STATE BUILDING CODE TECHNICAL REVIEW BOARD

Friday, August 15, 2025 - 10:00am

1. On February 14, 2025, the Fairfax County Department of Land Development Services (County), the agency responsible for the enforcement of Part 1 of the 2021 Virginia Uniform Statewide Building Code (VUSBC), denied a permit/plan review for BLDC-2024-00163 pertaining to the design of the project known as Eastgate Mixed Use submitted by Campbell Code Consulting (Campbell) which had only one exit. The determination of the County was that two exits were required due exit remoteness pursuant to VCC Section 1007.1.1 *Two exits or exit access doorways*.

Figure 1: Original design. Red cloud shows area where Fairfax County believes a second exit is required.

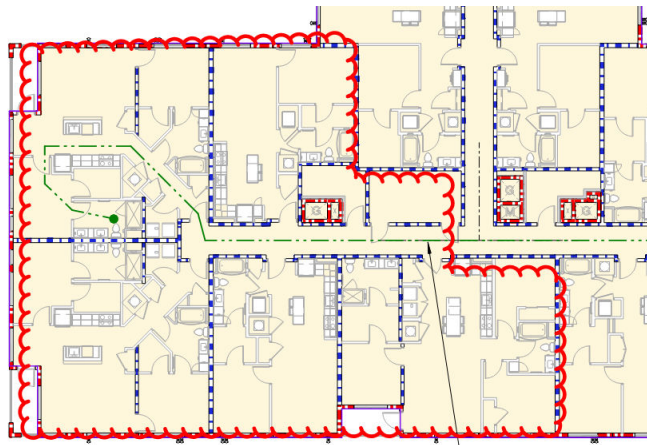
The design team received an initial permit comment from Tuong Nguyen regarding a single means of egress from the plan southwest corridor of the building. The comment essentially stated that this area has an occupant load greater than 20 occupants and requires two remote means of egress (citing VCC 1006.2.1). Please see Figure 1 showing the original design.

Figure 2: Updated design with relocated door (circled in red). Hatched region occupant load does not exceed 20.

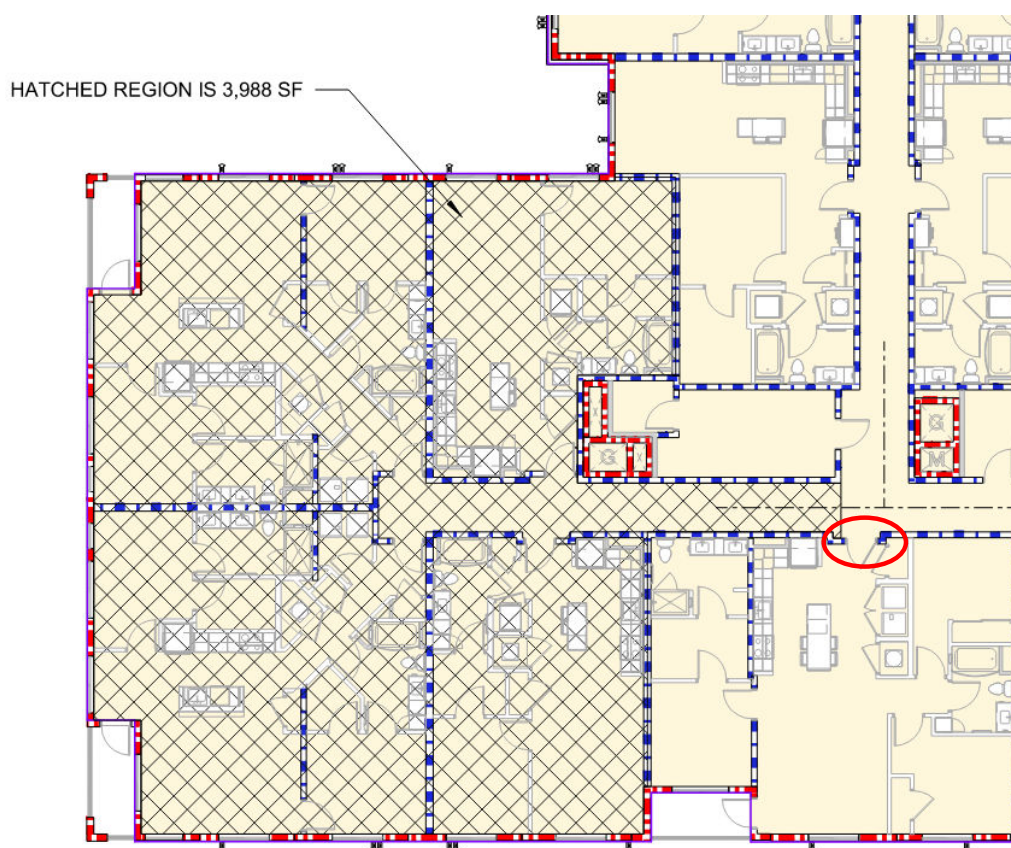
While we felt that the original design was compliant as submitted, the design team relocated the door of eastern-most unit to be past the corridor intersection point, hoping to address Fairfax County’s initial concerns. Please see the updated design in Figure 2 and Attachment 7.

Even with Fairfax County's approach to determining the number of required exits, this updated layout shows an occupant load of less than 20 occupants, which should satisfy the VCC 1006.2.1 requirement for a single exit from the space. Note that the hatched region is stopped just prior to the eastern-most unit in this updated layout, since occupants in that dwelling unit immediately have the choice of two exit access paths upon leaving the unit.

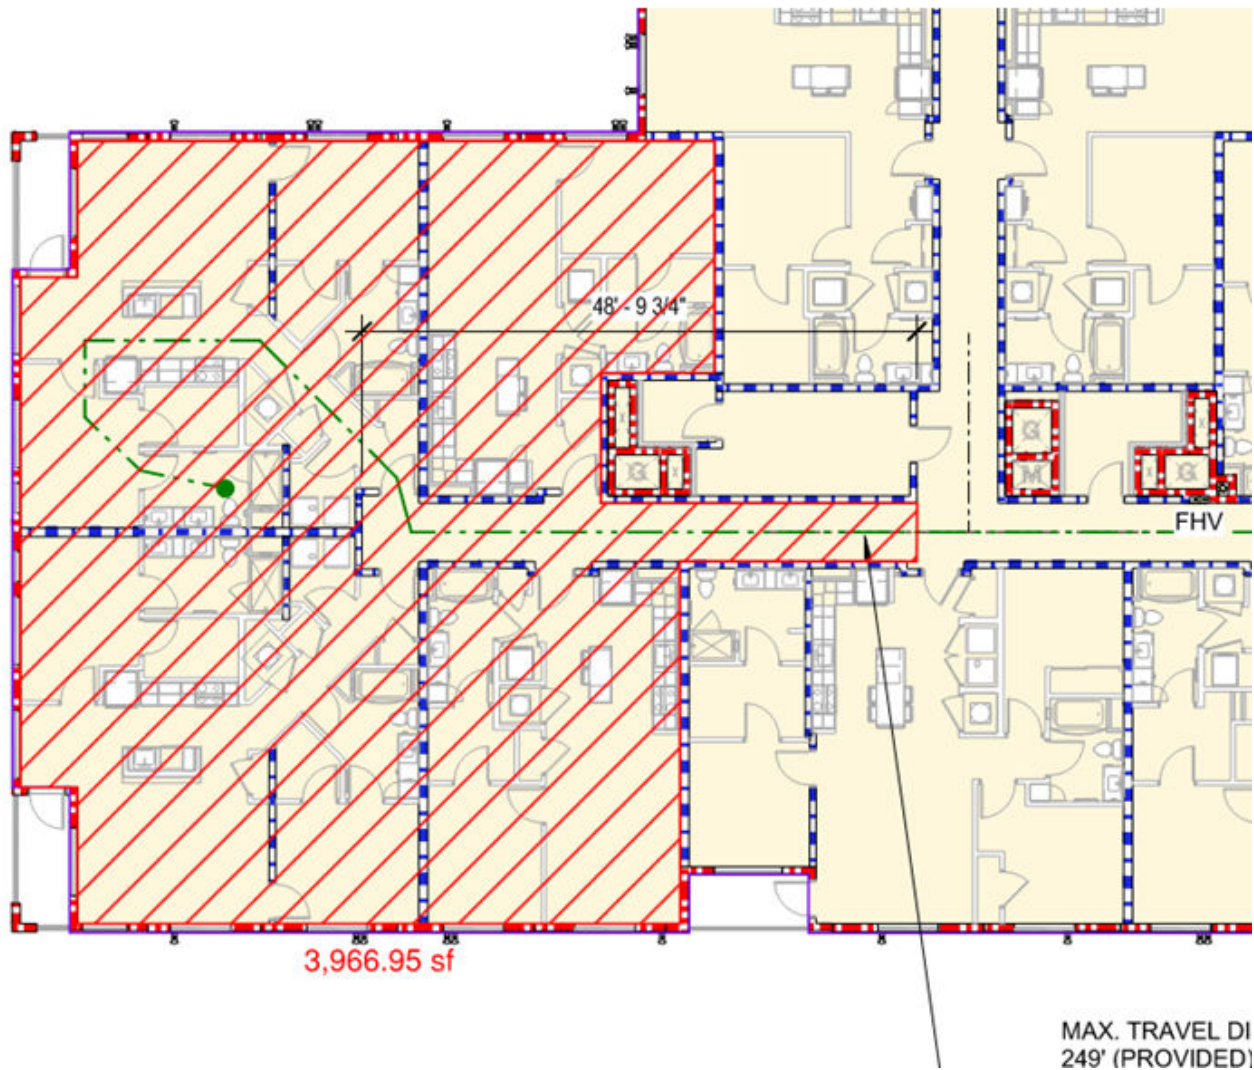
1. My opinion is that for the purposes of applying 1006.2.1, you would measure this wing of the building as shown below. This area is less than 4,000 SF (and therefore less than 20 occupants), so a single exit access point is acceptable.

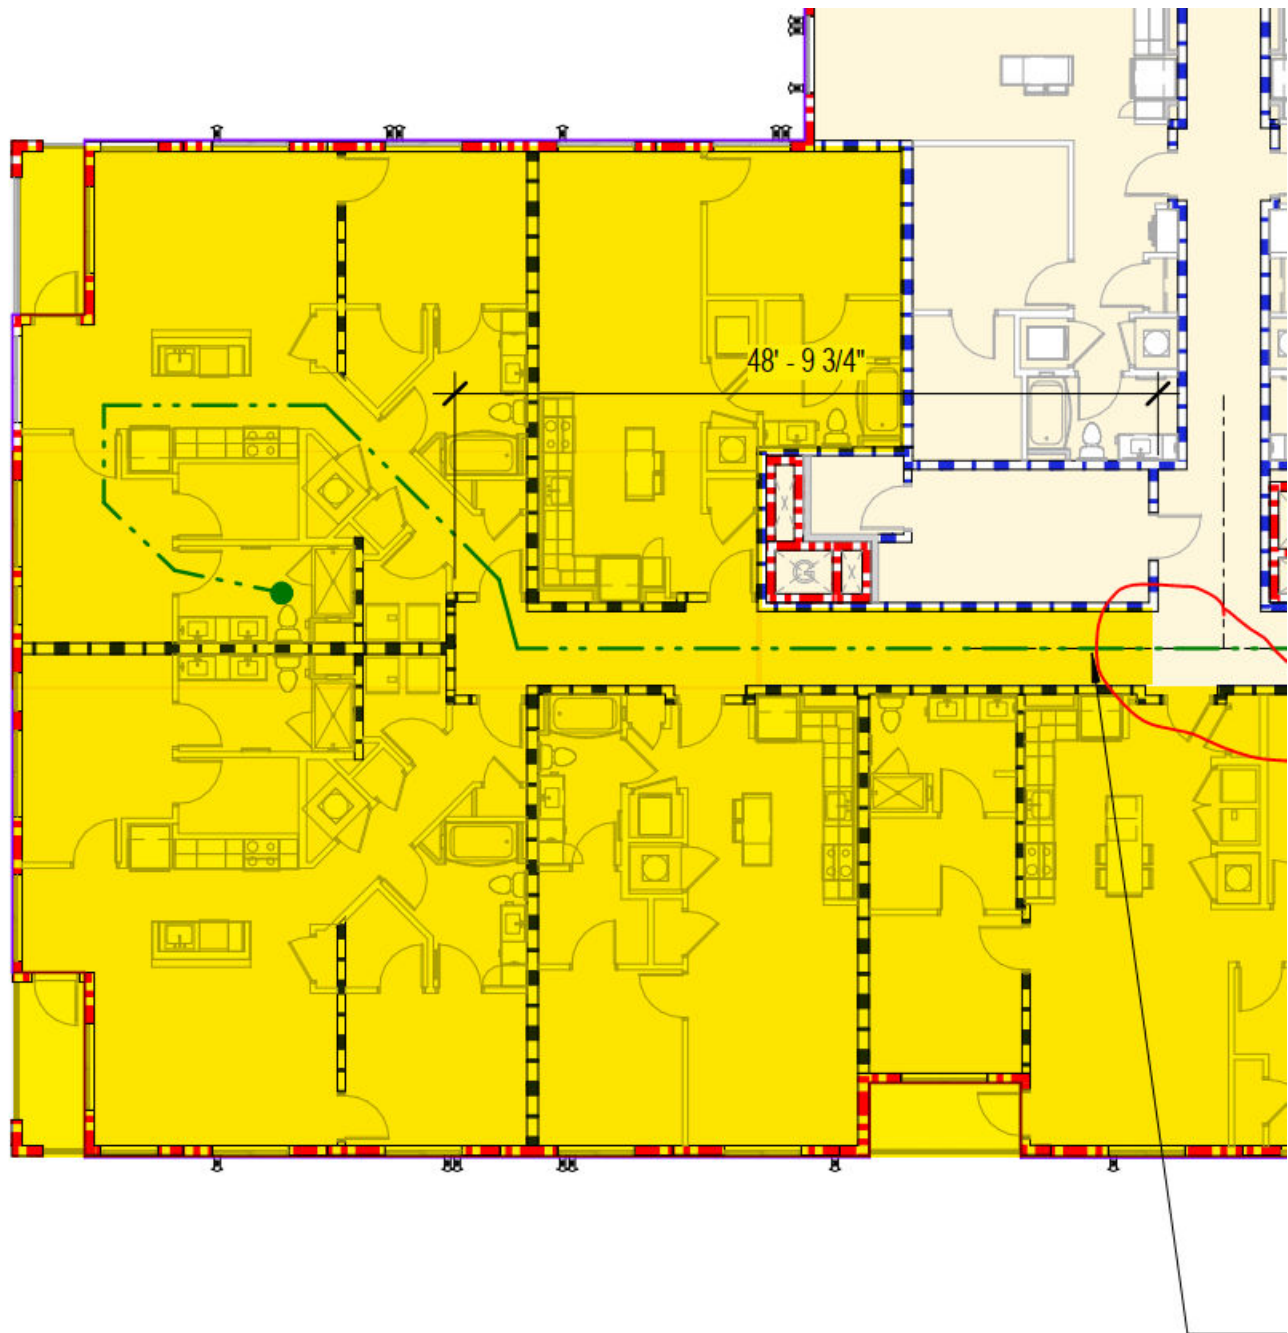
2. Dan's opinion is that the "space" measurement for the purposes of 1006.2.1 would be as shown below. This measurement incorporates an entire additional unit, is over 4,000 SF, and therefore over 20 occupants. Dan then believes a second exit access point is required from this space.

In my mind, the question is really hinging on the unit with an entry door right below the corridor intersection point. My take is that because occupants in this unit have zero common path immediately upon walking out of the unit, this unit should not be included in the “space” with only one exit. But Dan disagrees.

Figure 1

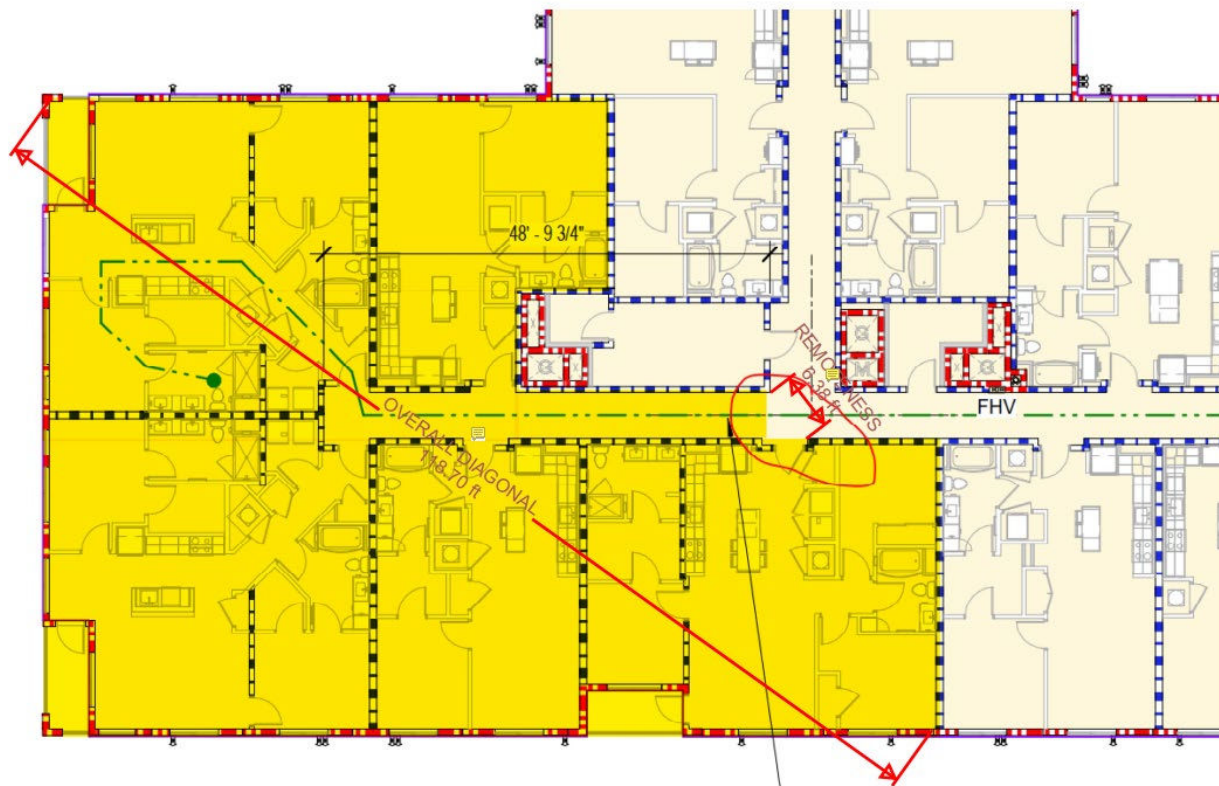
The intent of the code in requiring two remote means of egress is to limit the number of occupants that would be trapped by a fire event in a single location. This occupant load limit is 20 per [Table 1006.2.1](#). Furthermore, when two means of egress are required, they must be remote from one another as specified in [Section 1007.1.1](#) to ensure fire blocking one means of egress does not also affect the other (separated by one-quarter of the diagonal distance of the area served). A fire at the intersection of the corridor would trap over 20 occupants, which does not meet the intent of the code. Two means of egress are required from this combined space, and they must be remote from each other. The approximate actual dimensions for the remoteness measurement are illustrated in Figure 1 below:

The appellant argues that the combined occupant load should not be used in this case for the determination of the number of means of egress. The dwelling units share a common corridor. The appellant argues that “only” the egress path capacity is regulated for intervening spaces, such as this common corridor. That is not what the code language says (see [2018 VCC Section 1004.2.1](#)). There is no “only” in this code language. Conversely, the first sentence explicitly states that the design occupant load shall be the combined occupant load of interconnected spaces but then adds that the egress path capacity shall also be designed for the combined occupant load:

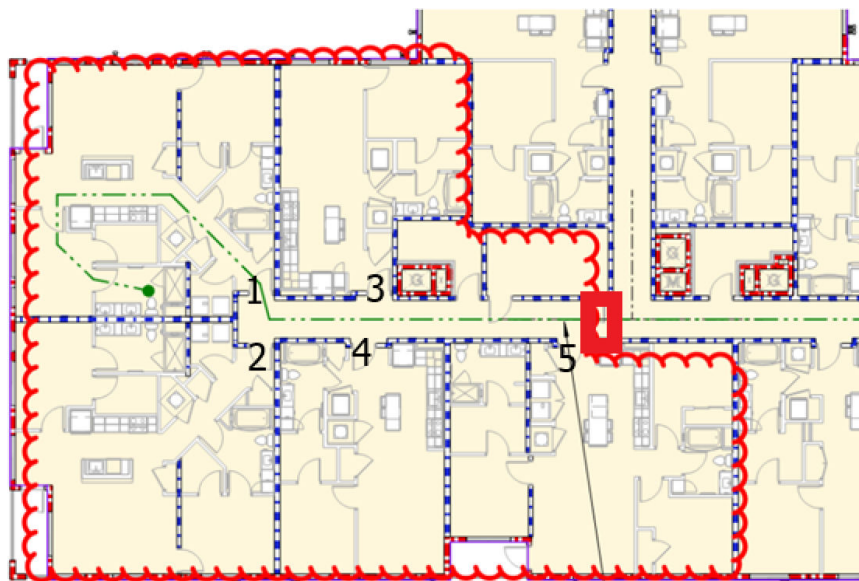
Part of the intent and spirit of the Code is to limit the number of people who may be trapped by a single blocked fire exit. Pursuant to Table 1006.2.1., the maximum occupant load of a space with a single exit or exit access doorway for the R-2 Group Occupancy is 20 persons. At §1006.2.1, the Code states “[t]wo *exits* or *exit access doorways* from any space shall be provided where the design *occupant load* or the *common path of egress* travel distance exceeds the values *listed* in Table 1006.2.1.” (emphasis in original). This statement in the code is disjunctive – so long as the occupant load exceeds 20 persons, absent an applicable exception, the space will require two exits. So, because the design occupant load exceeds 20 persons, two exits are required. Both parties agree that the occupant load for the outlined space exceeds 20 persons.

Applying the Code, that exit is not just a single door; rather, it is a single space through which part or all of the occupant load must pass to exit the building. In the area shown in the previous diagram, the highlighted area is served by a single exit, the precise location of the exit being shown using an annotated version of the previous diagram on the following page:

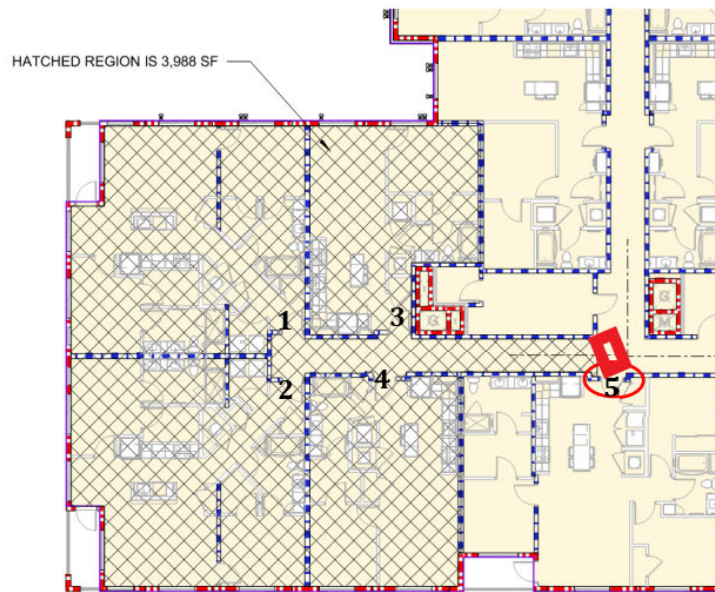
Each apartment egress is labeled 1-5. Each opens into a hallway and all paths of egress must necessarily pass through space indicated by the red rectangle – that is the single fire exit serving these five apartments. If a fire covered or blocked that space, every resident of those five apartments would be trapped without a means of egress. To the right of the red rectangle, the hallway forks, leading to different egresses from the building. However, because more than 20 persons have to exit through the space covered by the red rectangle to escape, another remote means of egress is required to serve the entire occupant load.¹ Therefore, through straight application of the Code requirements, this design is not compliant.

¹ The fork in the hallway does provide access to two different egresses; however, the hallway fork cannot provide two Code-compliant exits because the corridor is not wide enough to comply with the remoteness criteria required by §1007.1.1.

Figure 1: Original design. Red cloud shows area where Fairfax County believes a second exit is required.

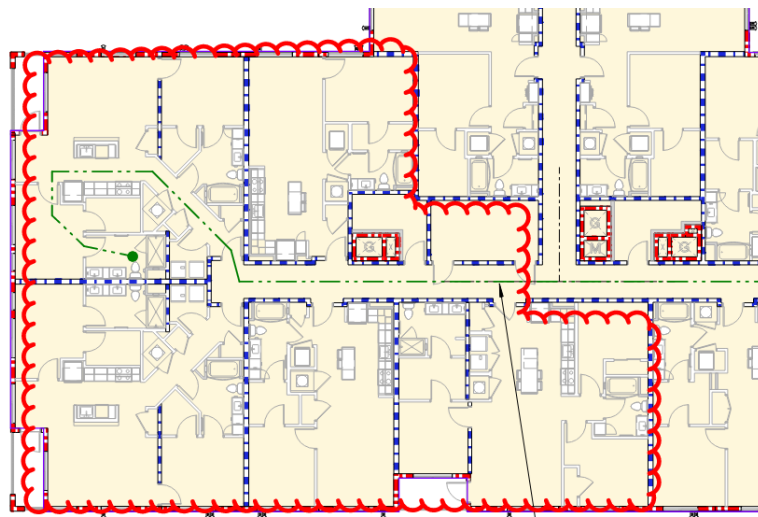
The design team received an initial permit comment from Tuong Nguyen regarding a single means of egress from the plan southwest corridor of the building. The comment essentially stated that this area has an occupant load greater than 20 occupants and requires two remote means of egress (citing VCC 1006.2.1). Please see Figure 1 showing the original design.

Figure 2: Updated design with relocated door (circled in red). Hatched region occupant load does not exceed 20.

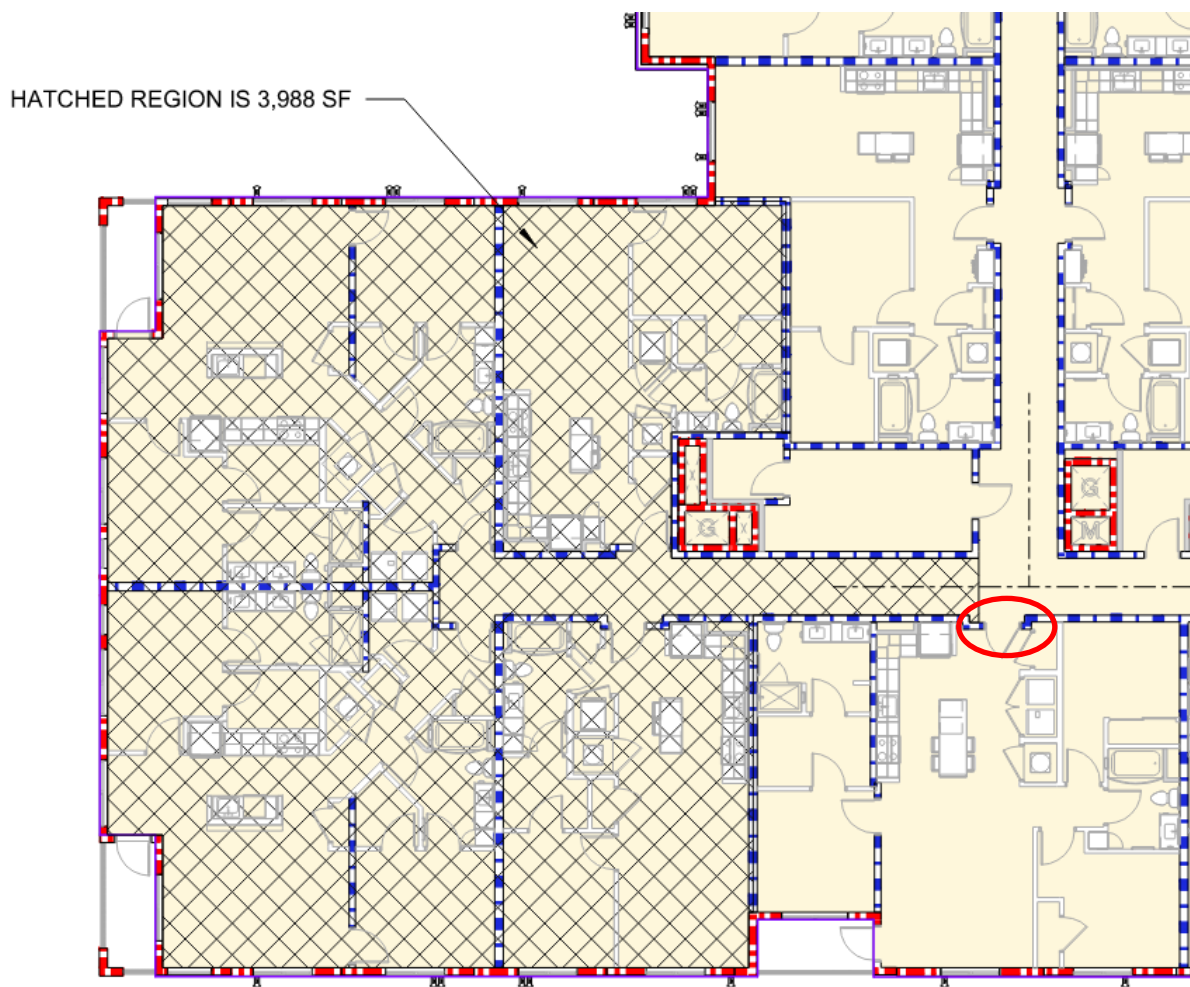
While we felt that the original design was compliant as submitted, the design team relocated the door of eastern-most unit to be past the corridor intersection point, hoping to address Fairfax County's initial concerns. Please see the updated design in Figure 2 and Attachment 7.

Even with Fairfax County's approach to determining the number of required exits, this updated layout shows an occupant load of less than 20 occupants, which should satisfy the VCC 1006.2.1 requirement for a single exit from the space. Note that the hatched region is stopped just prior to the eastern-most unit in this updated layout, since occupants in that dwelling unit immediately have the choice of two exit access paths upon leaving the unit.

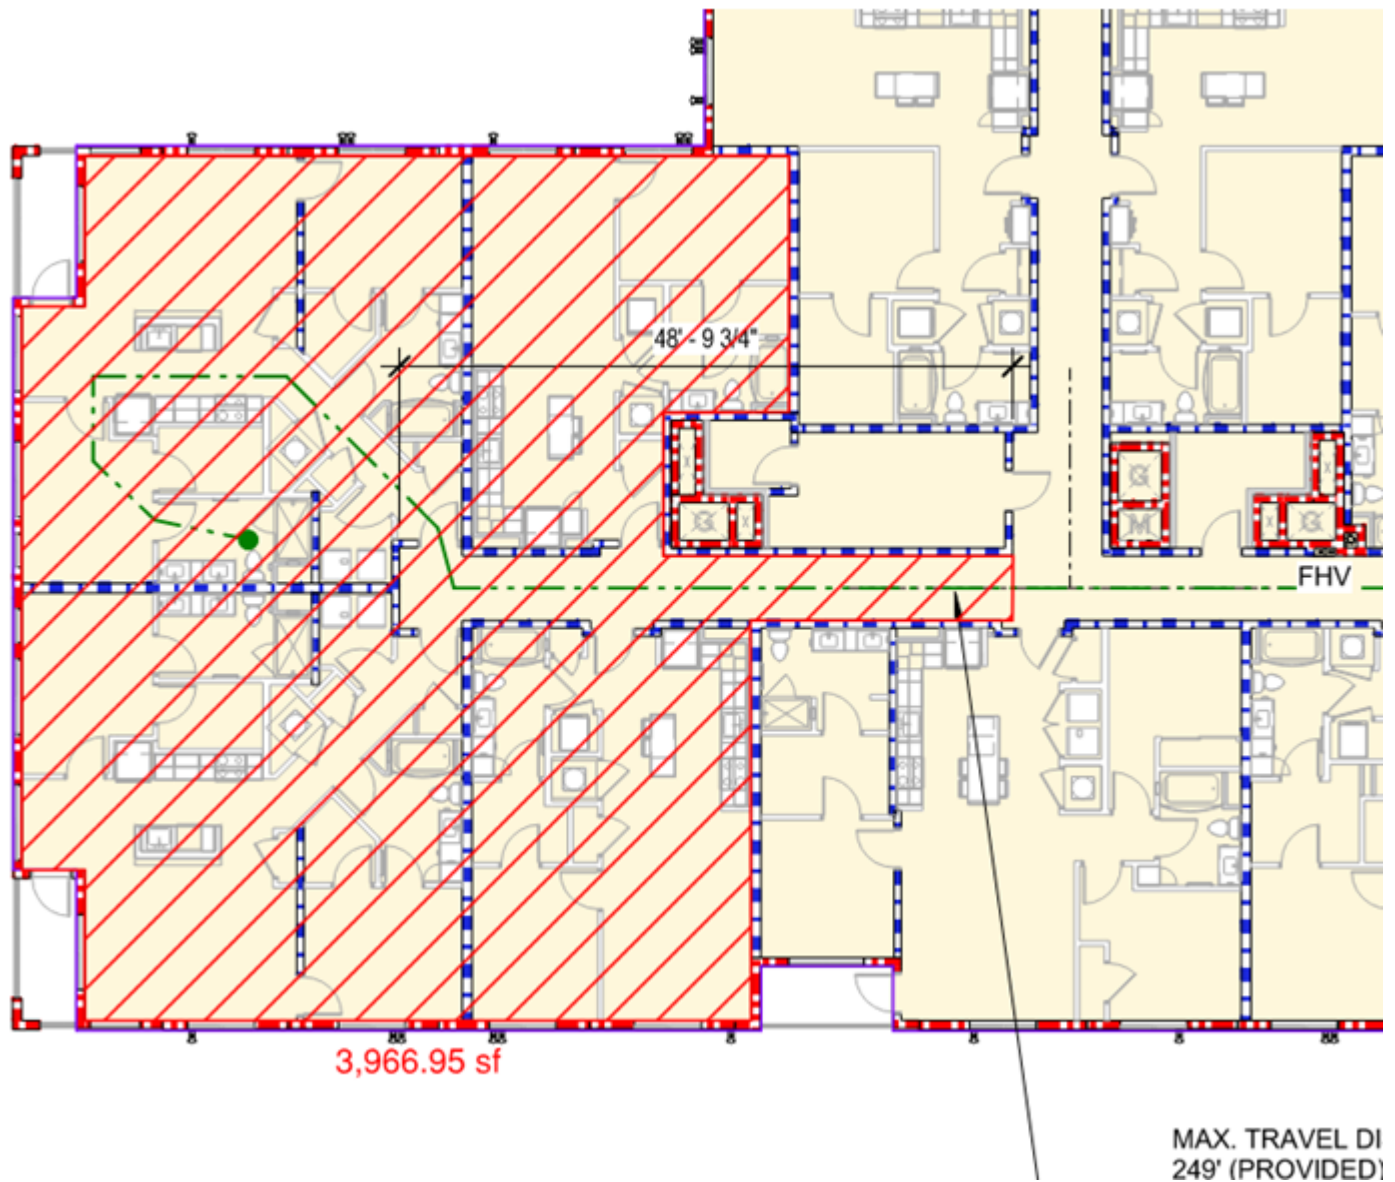
1. My opinion is that for the purposes of applying 1006.2.1, you would measure this wing of the building as shown below. This area is less than 4,000 SF (and therefore less than 20 occupants), so a single exit access point is acceptable.
